# UNITED STATES PATENT AND TRADEMARK OFFICE

APPLICATION NO.	FILING DATE	FIRST NAMED INVENTOR	ATTORNEY DOCKET NO.	CONFIRMATION NO.
10/720,767	11/24/2003	Jack A. Smith	090936.0529	4914

<b>Office Action Summary</b>	<b>Application No.</b> 10/720,767	<b>Applicant(s)</b> SMITH ET AL.	
	<b>Examiner</b> Vikansha S. Dwivedi	<b>Art Unit</b> 3746

## DETAILED ACTION

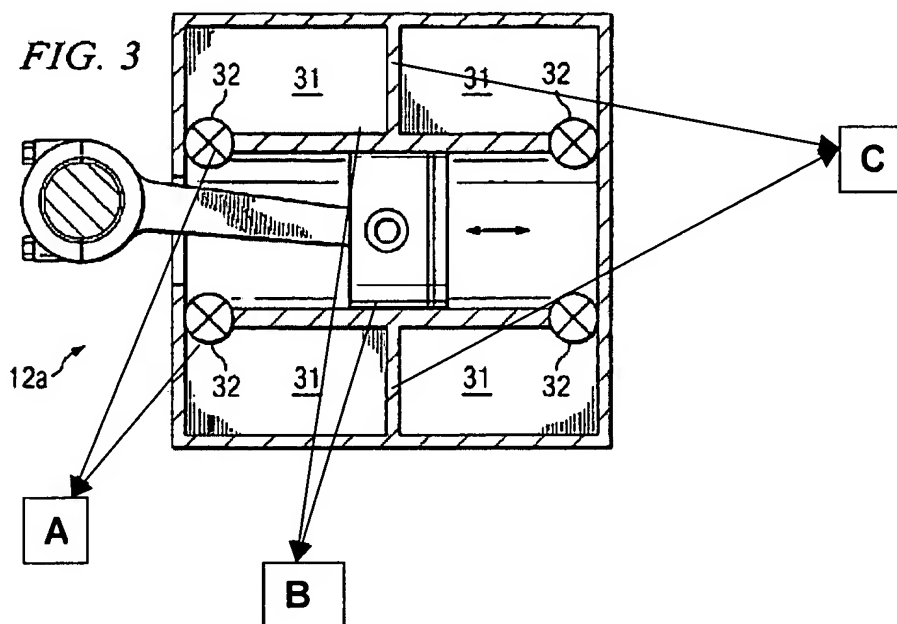
For the purpose of examination examiner is considering numeral 31 to define load pockets as shown in figure 3. It is not clear from the disclosure how the load pockets (31) change the compression ratio of the compressor. Further the use of the term discrete load is ambiguous.

The drawings are objected to because it is not clear how are valves (32) closer to the cam (As seen in figure 3 towards the left hand side) affect the unloading. It seems from the drawing that only two valves (32) that are located on the extreme right will facilitate unloading the compressor, it seems that if the set of valve A as indicated below will be useful in unloading if they were located at position B or C.

Since the drawings do not illustrate the valves in a manner that would create a properly unloaded compressor (for the left load pockets 31), one of ordinary skill in the art is not properly taught how to make and use the claimed invention.

Applicant is suggested to either provide an explanation for the current position of the valves and how they affect the unloading or provide corrected drawing. Corrected drawing sheets in compliance with 37 CFR 1.121(d) are required in reply to the Office action to avoid abandonment of the application. Any amended replacement drawing sheet should include all of the figures appearing on the immediate prior version of the sheet, even if only one figure is being amended. The figure or figure number of an amended drawing should not be labeled as "amended." If a drawing figure is to be
